State of Alaska
Department of Fish and Game
Habitat and Restoration Division

Nomination for Waters Important to Anadromous Fish

Anadromous Water Catalog Number of Waterway: 182-70-11400-2010-3009-4035-5010

Name of Waterway: Seal Creek ☑ USGS Name ☐ Local Name

SealStrms9-12.jpg

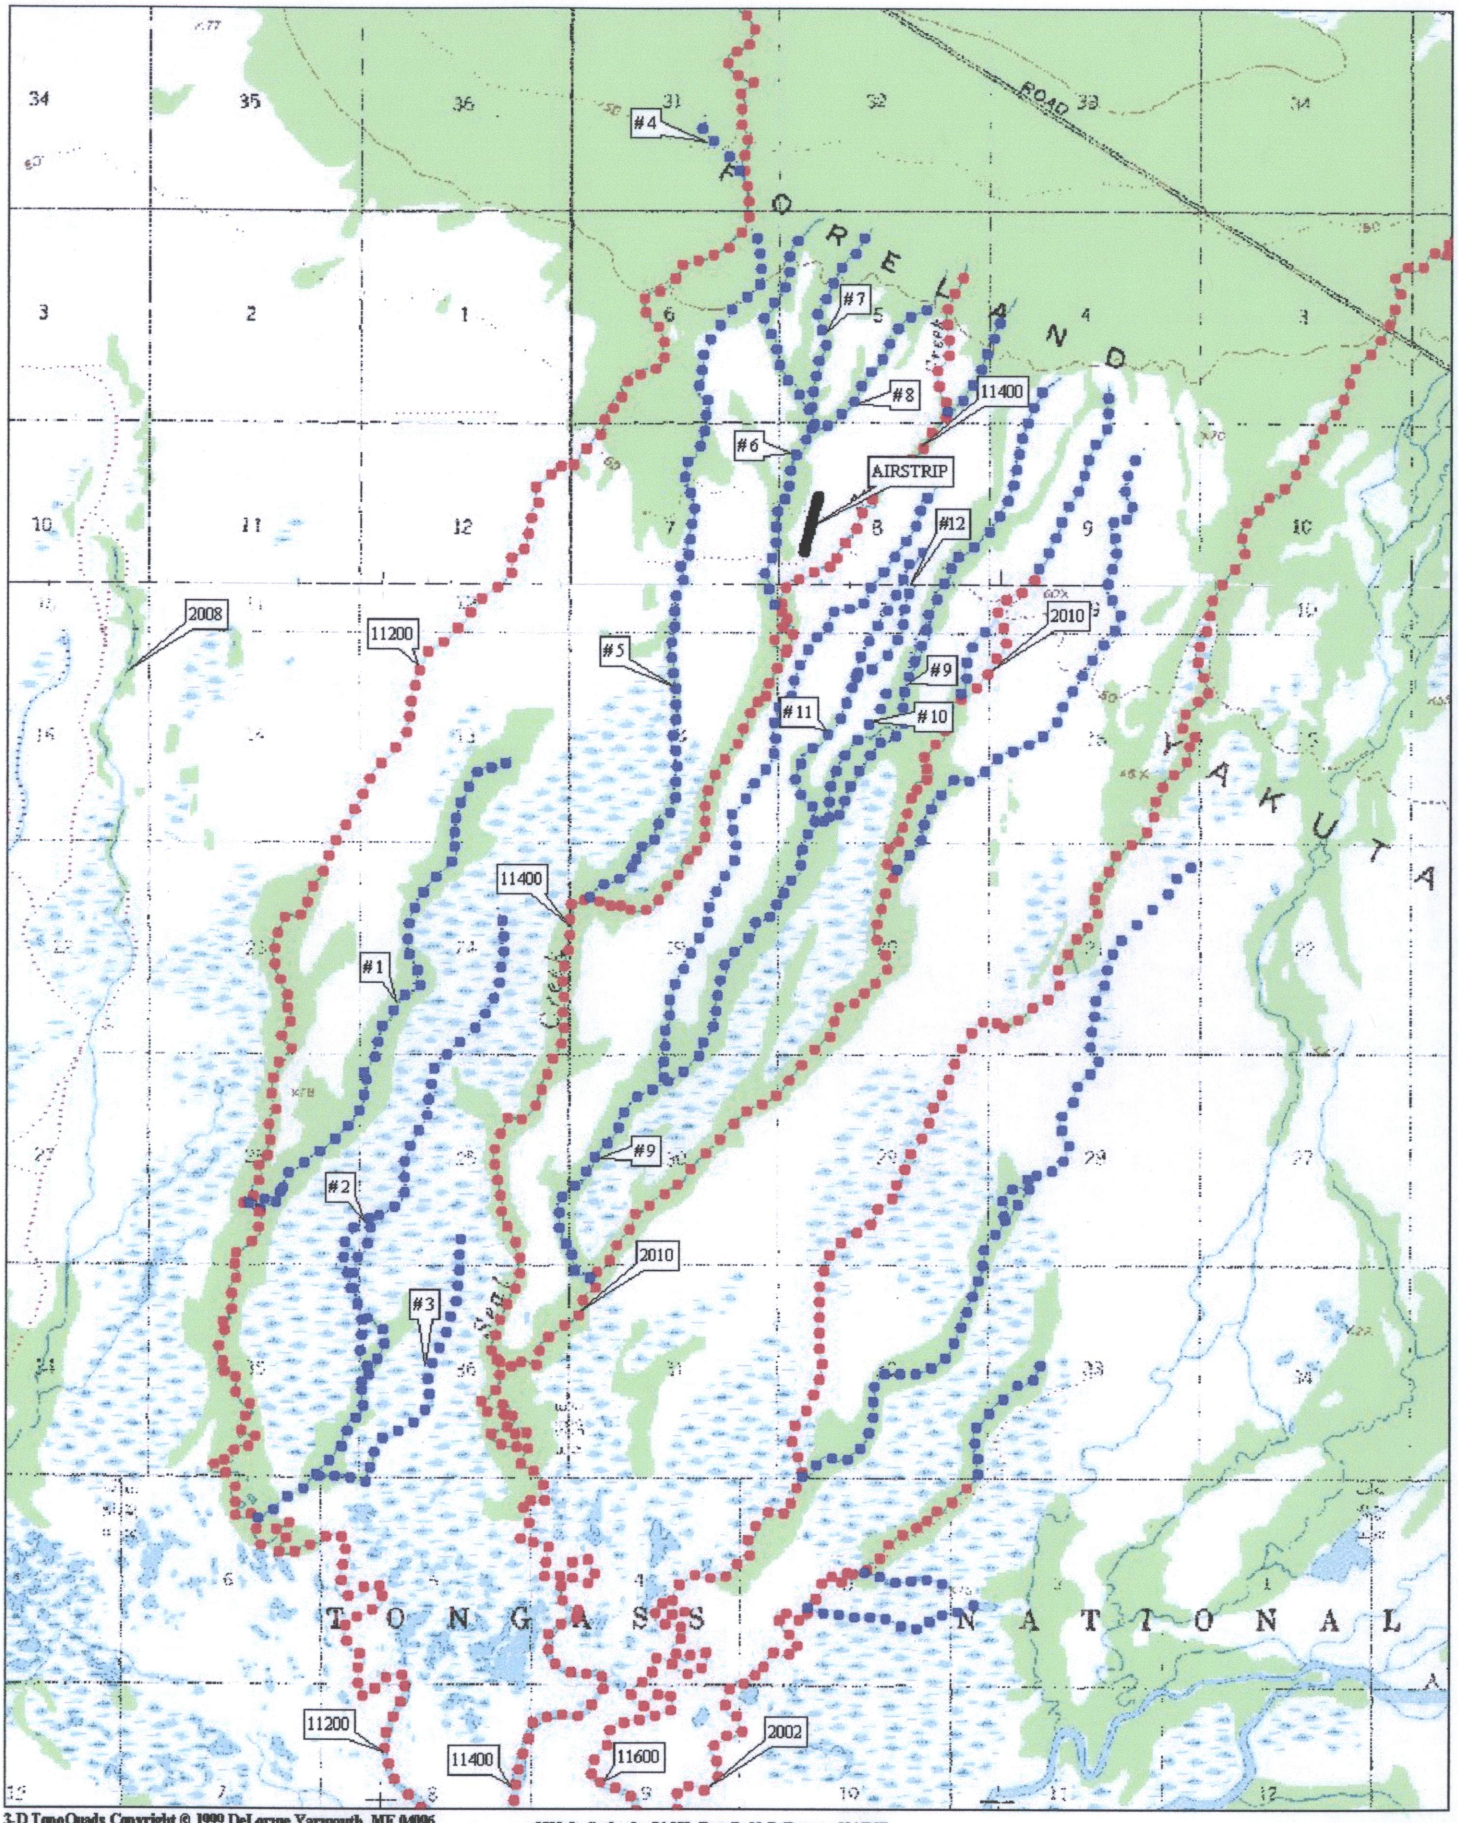
Comments: Location; Township 28S Range 36E Section NW 1/4 17 ; Latitude N59 degrees 29.604, Longitude W139 degrees 21.220 (NAD27). This is stream 12 on the map.

Add STREAM 182-70-11400-2010-3009-4035-5010 w/ CORP

SealCrkQ2X.jpg

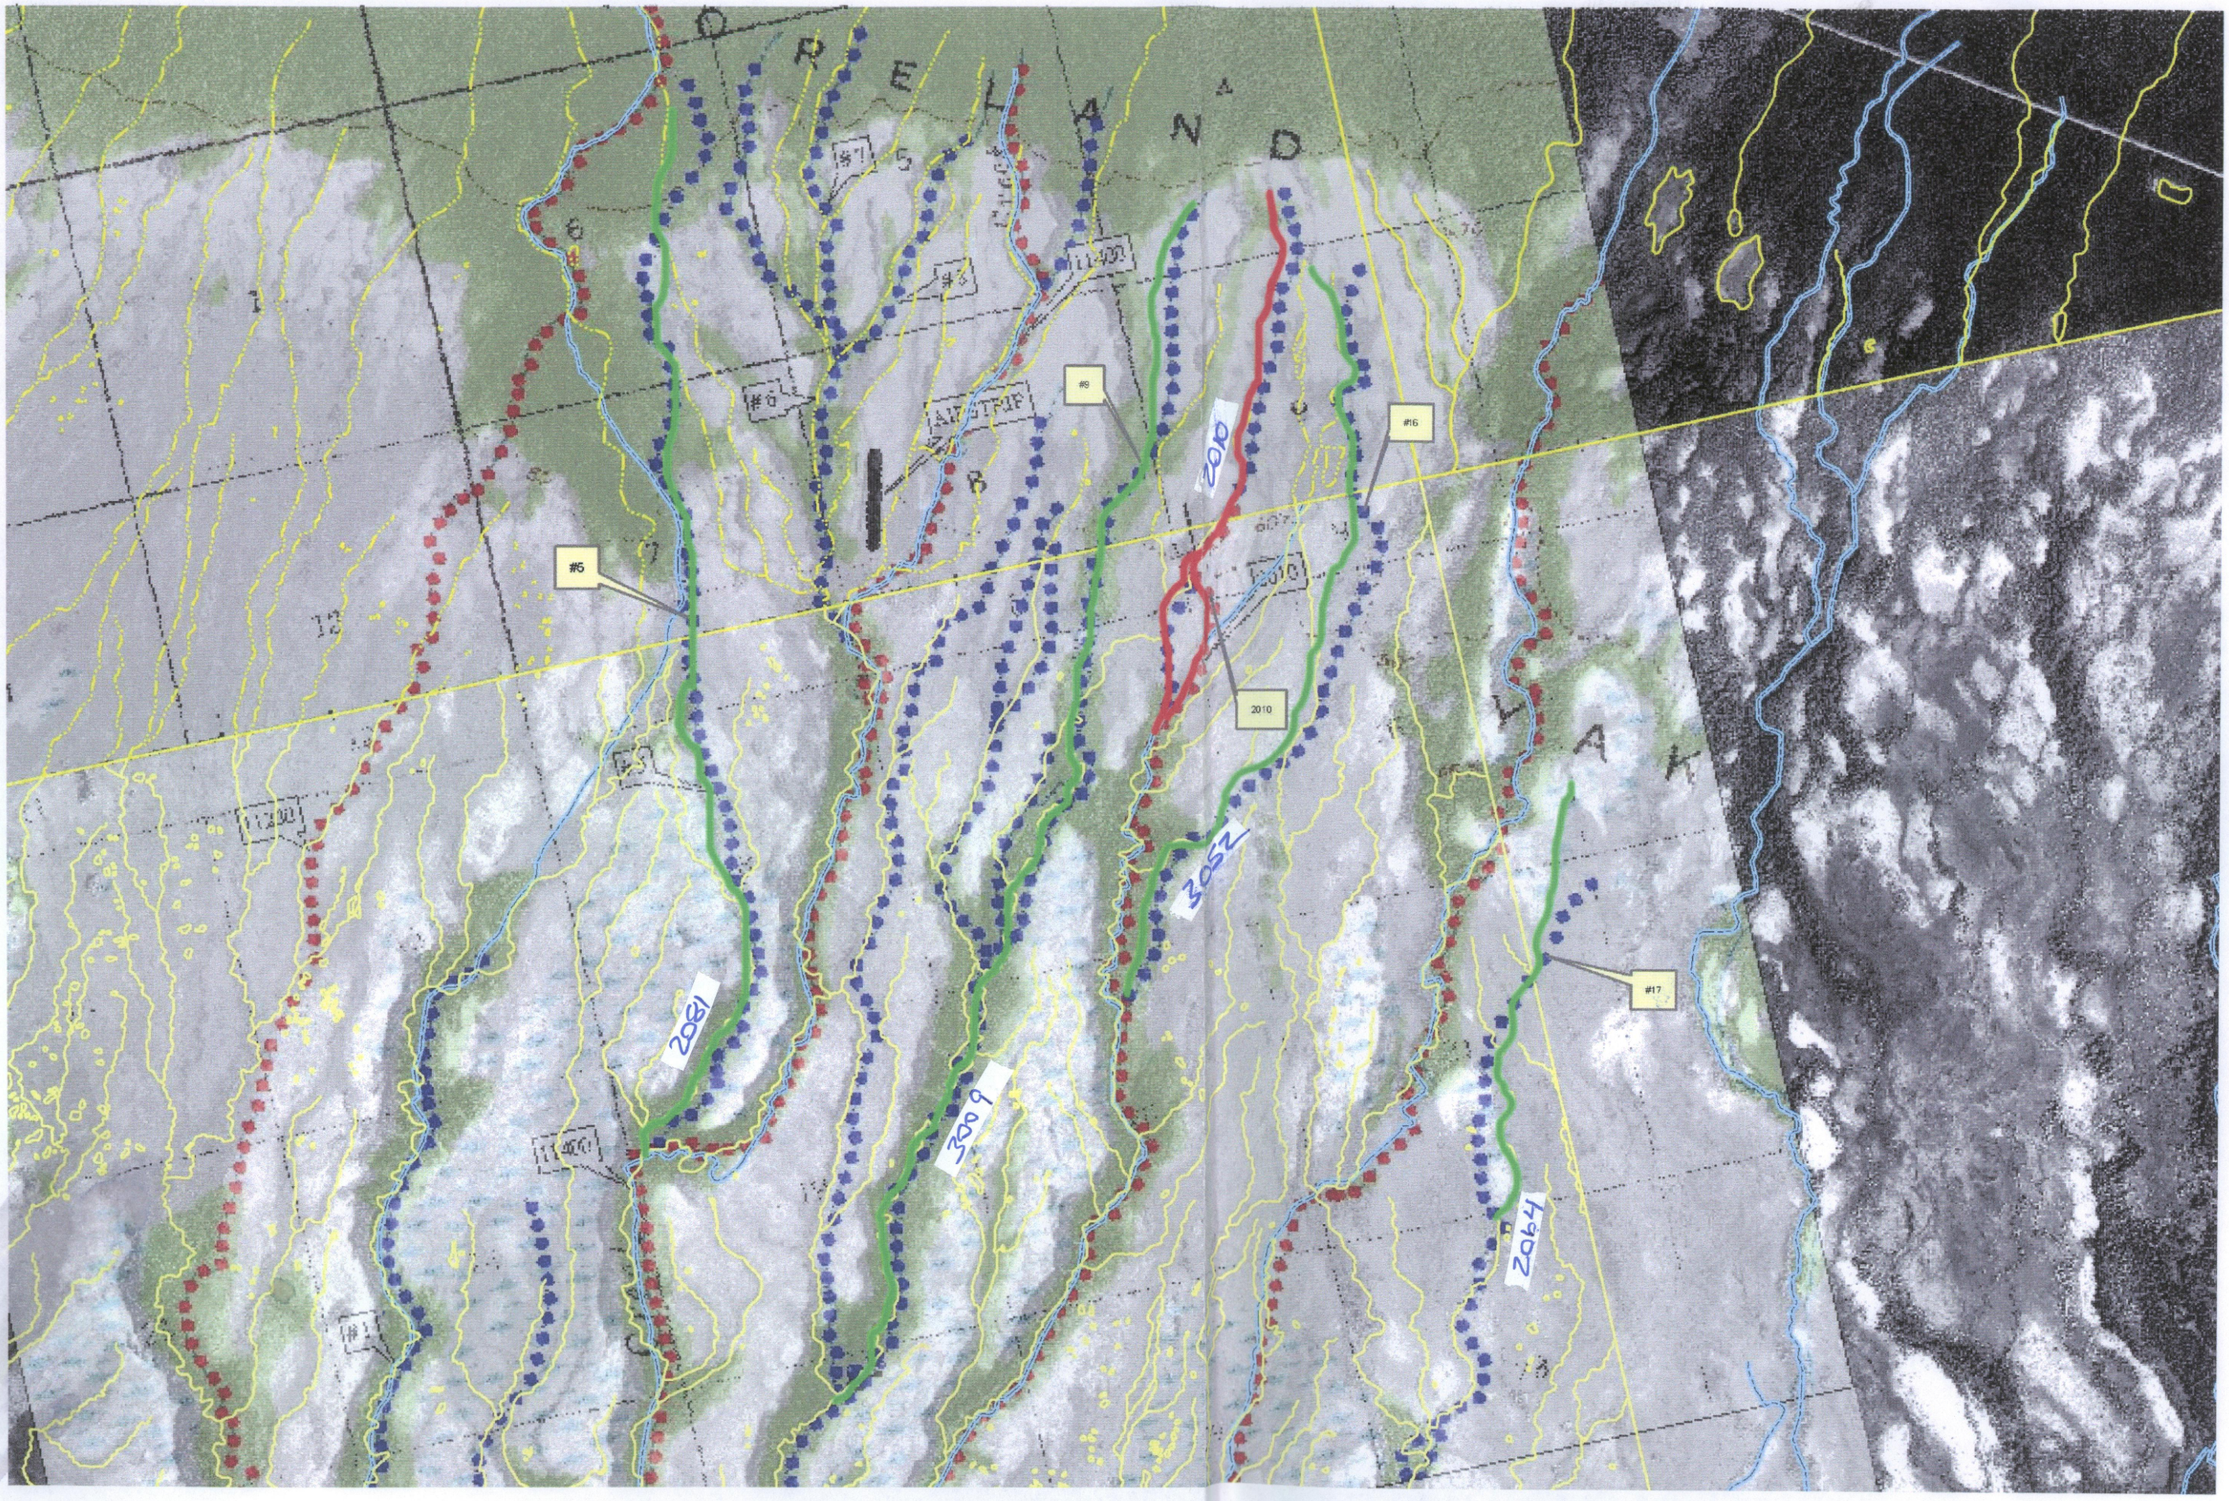
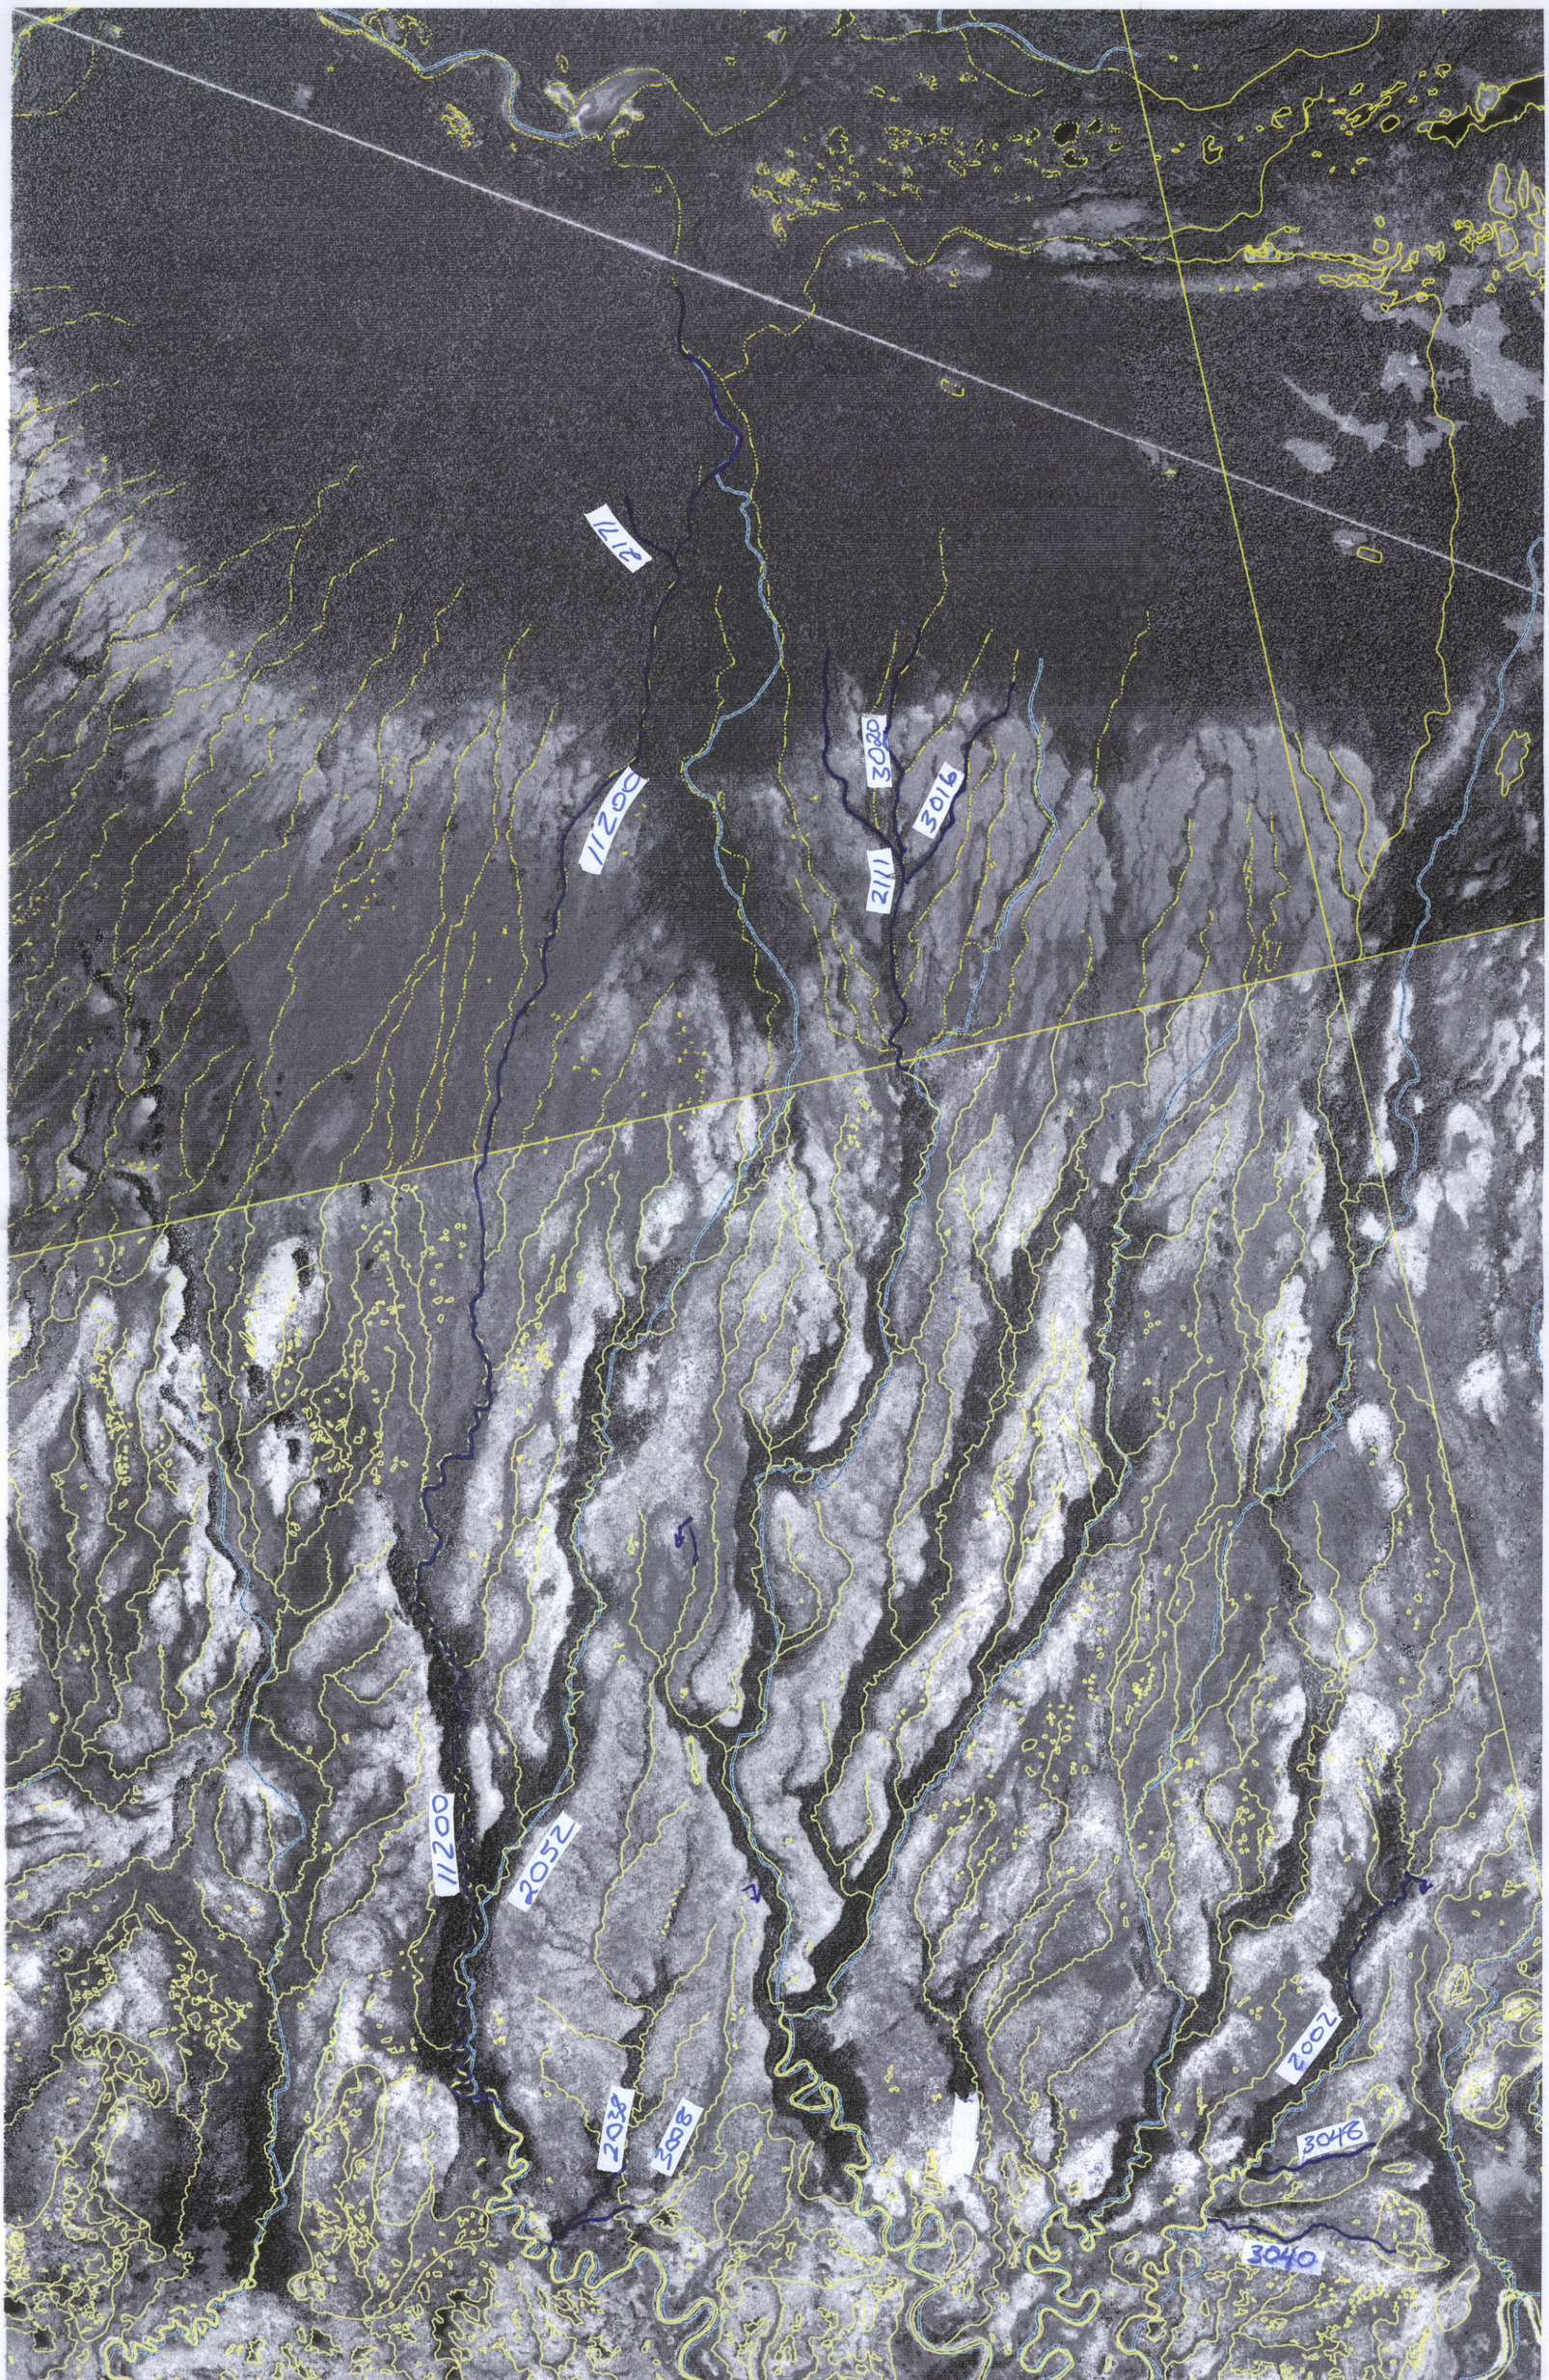
MOVE HYDRO FOR 11200 AS NOTED. ALSO NOTE CHANGES TO UPPER & LOWER ENDS of 2038

Looks like a few more of these are jumping between the different hydro streams that I have. Can you look at the attached Jpeg and let me know where the stream should lie for streams 5, 9, 16, 17 and there's also something going on there with the upper section of 2010. I've overlain your original submittal with the hydro and photo in the jpeg.

Ed - here's the modified jpg for this. This was is pretty tough because of the beaver dam activity throughout this upper area re-routing water every-which-way. My best guess.... Phil
